AMENDMENT OF SOLICITATION/MODIFICATION OF CONTRACT			1. Contract Number	Page of Pages	
				1	13
2. Amendment/Modification Number	3. Effective Date	4. Requisition/Purchase Request No.		5. Solicitation Caption	
GF-2011-B-0028-002	August 1, 2011			Renovation of "C" Level Offices at Buildings 38 & 39 - Phase II

14. Description of amendment/modification (Organized by UCF Section headings, including solicitation/contract subject matter where feasible.)					
Solicitation No. GF-2011-B-0028 for Renovation of "C" Level Offices at Buildings 38 & 39 - PHASE II is hereby amended as follows:

Gf-2011-B-0028
Renovation of "C" Level Offices at Buildings 38 & 39 – Phase II
Additional Questions and Answers

Sheet A901 (Attached)

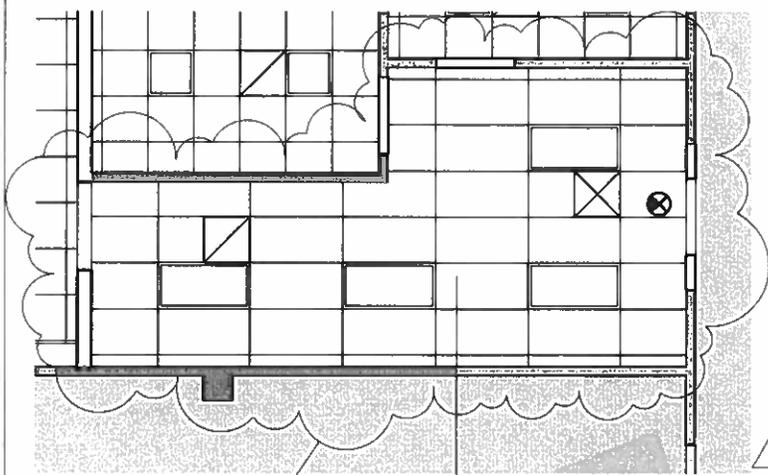
1. Add General Note #25. “All Phase II wall finishes shall be Protective Wall Finish. Final color selection by Architect. Refer to specifications.”

A-SK01

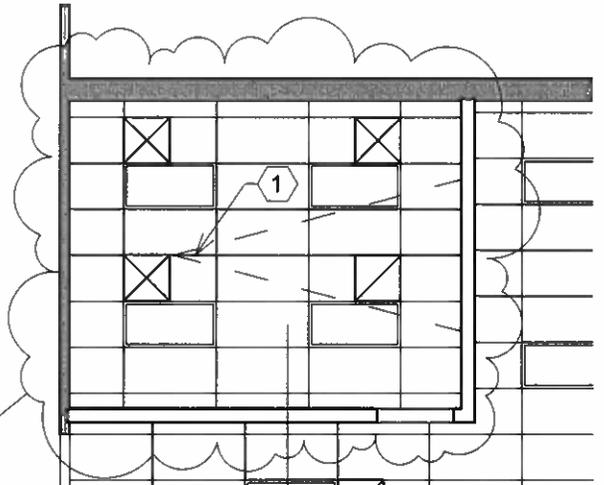
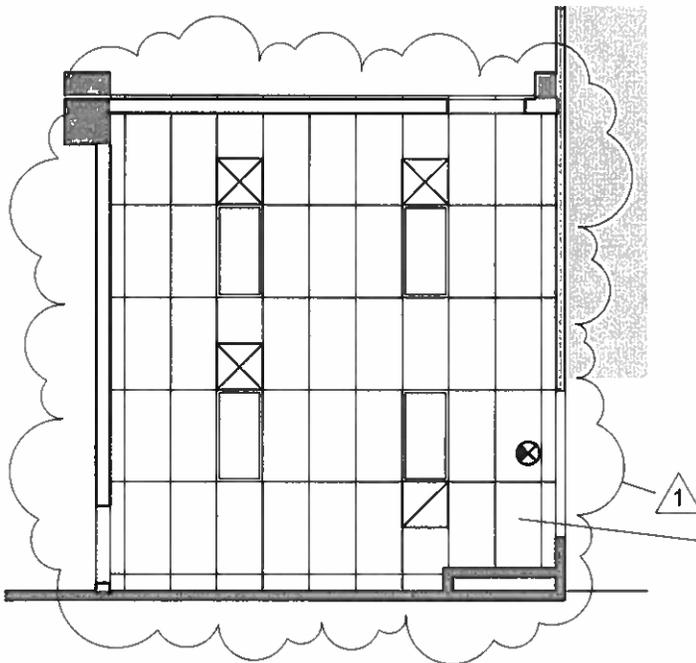
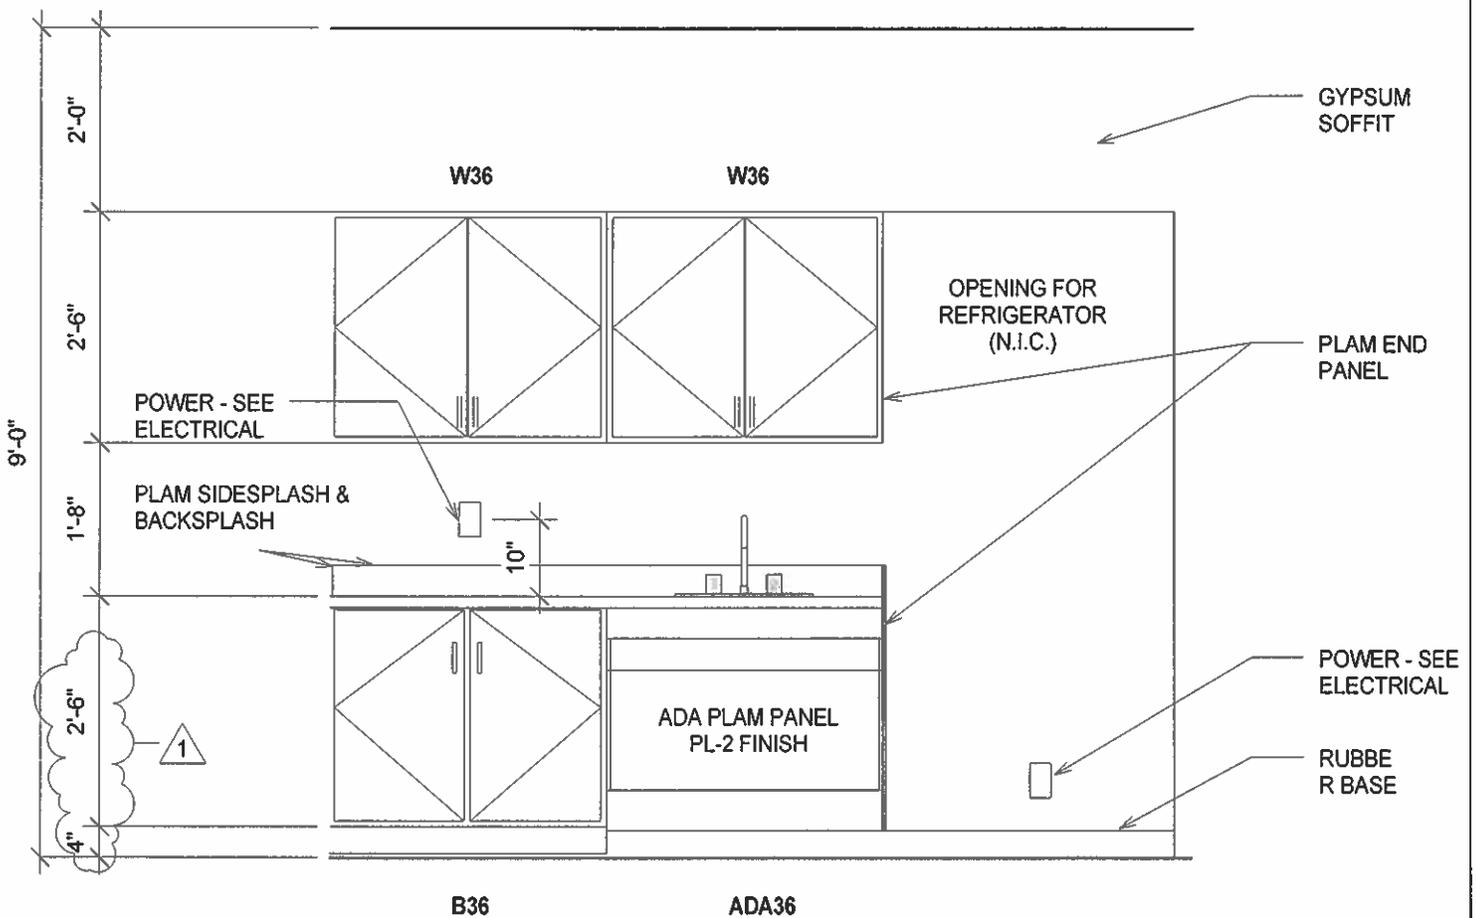
1. Add the following RCP note to Maintenance 39/C22: “Coordinate final ceiling height with existing conditions.”
2. Revise 38/C21 Reception ceiling per attached sketch.
3. Revise 38/C20 Reception ceiling per attached sketch.
4. Revise 39/C22D Maintenance Conference Room ceiling per attached sketch.

A-SK02

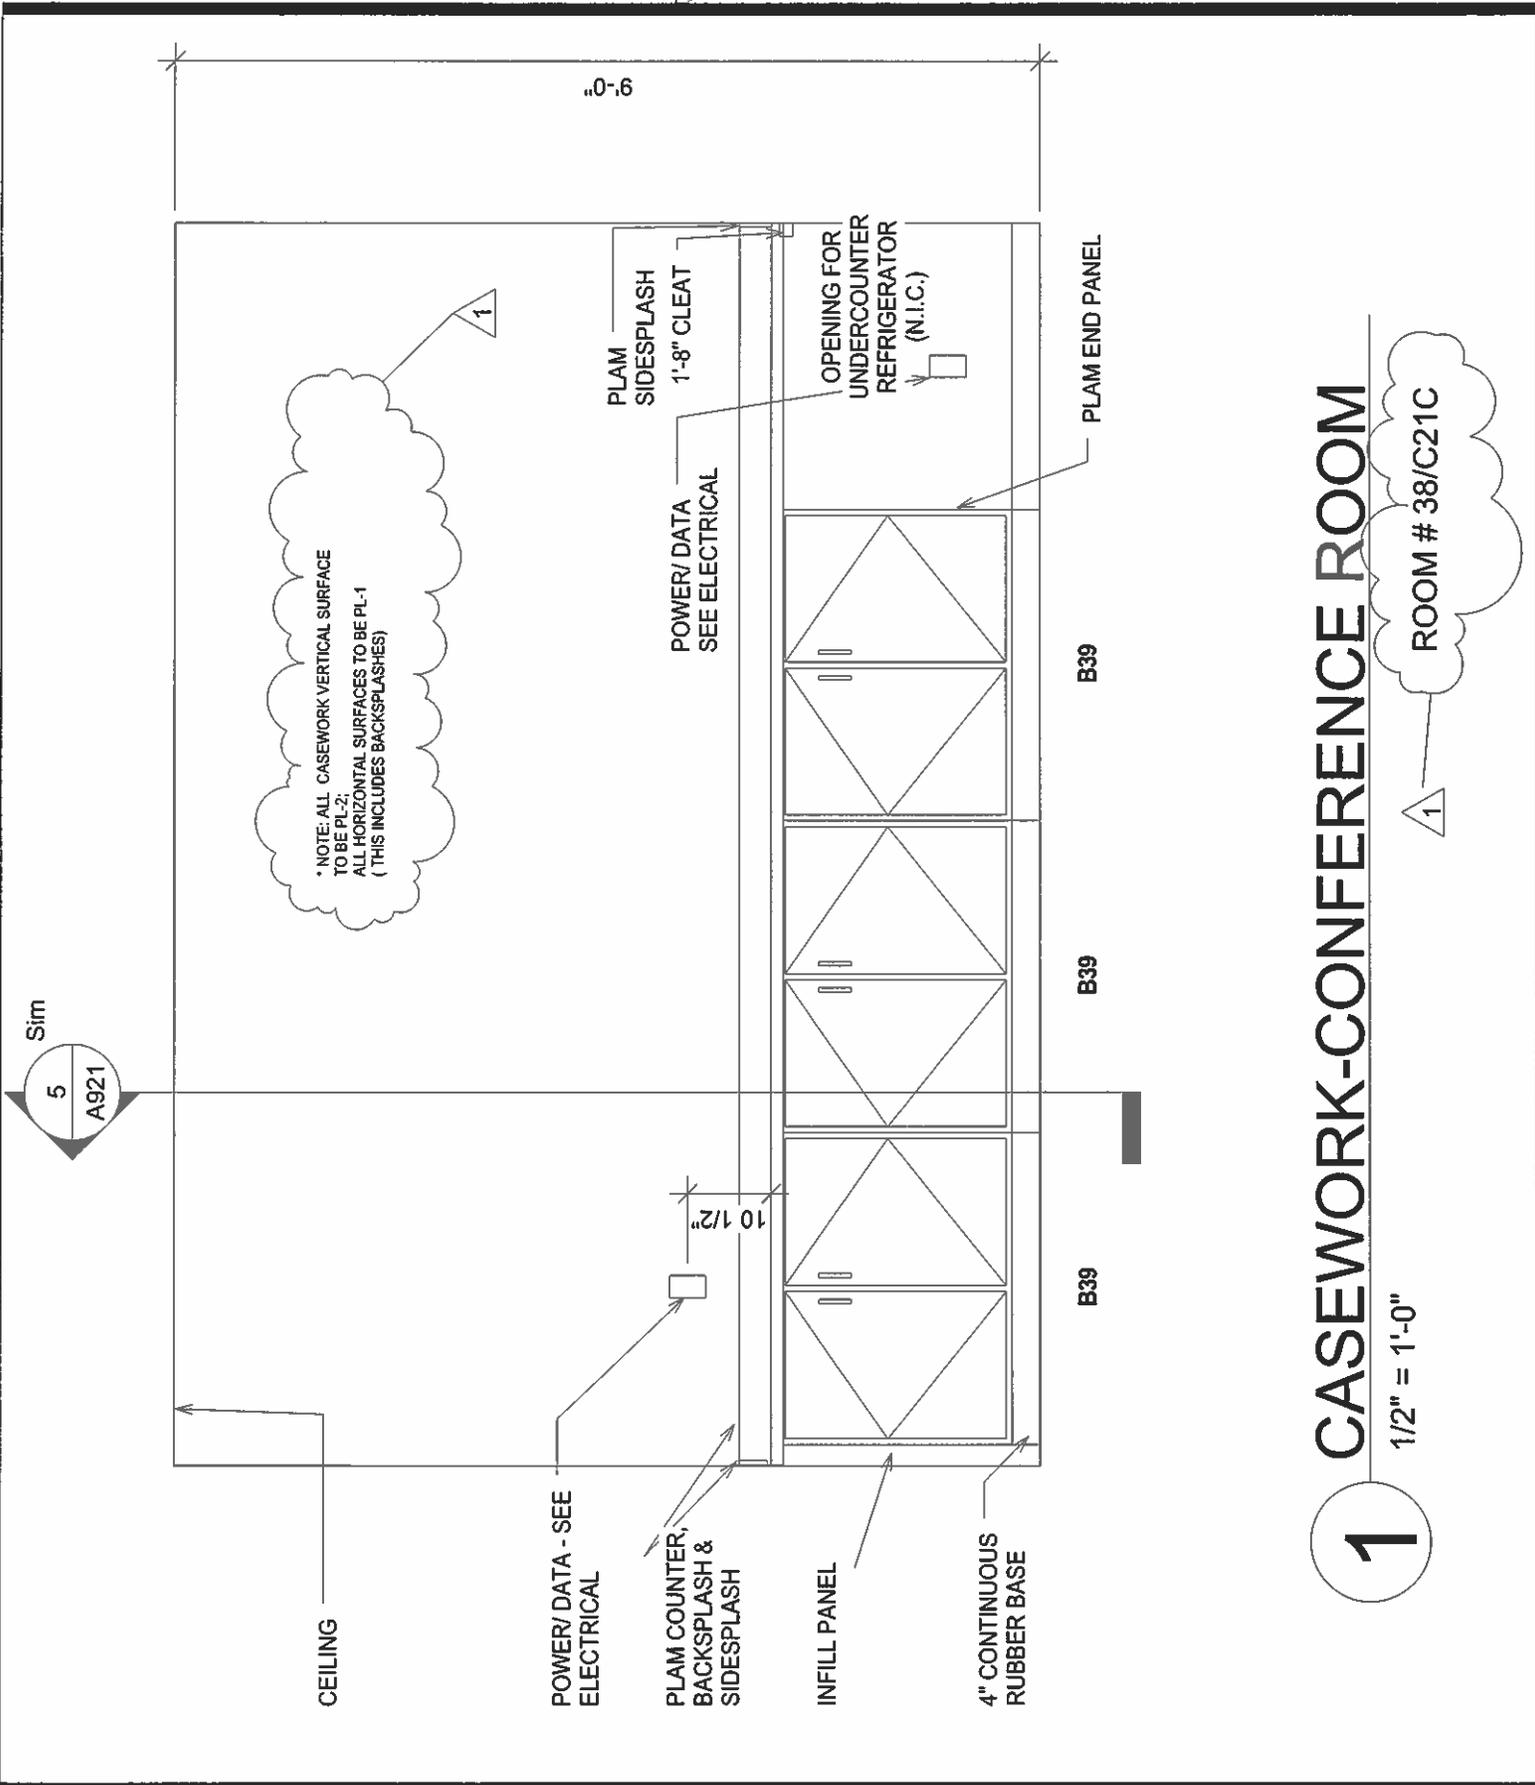
1. Delete Detail 1/A921 and insert Sketch ASK01 (Attachment B).
2. Delete Detail 2/A921 and insert Sketch ASK02 (Attachment C).
3. Delete Detail 12/A921 and insert Sketch ASK03 (Attachment D).
4. Delete Detail 13/A921 and insert Sketch ASK04 (Attachment E).
